## BOARD OF WATER SUPPLY

May 27, 2016

Subject: Board of Water Supply (BWS) Comments to the Work Plans Being Developed Under the Red Hill Bulk Fuel Storage Facility Administrative Order on Consent (AOC) Statement of Work (SOW) Sections 2 through 5 and 8

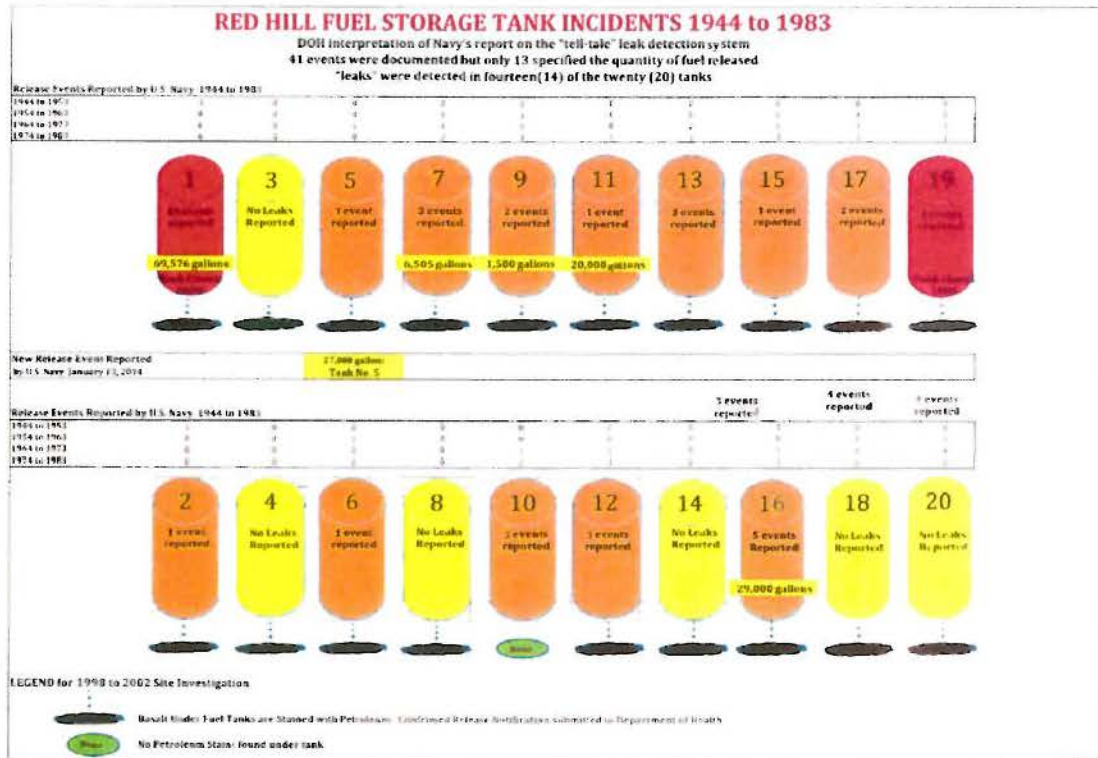
Provide a table that lists what is known about prior leaks. The Hawaii Department of Health's (DOH) chart shown below provides a basis for what should be included.
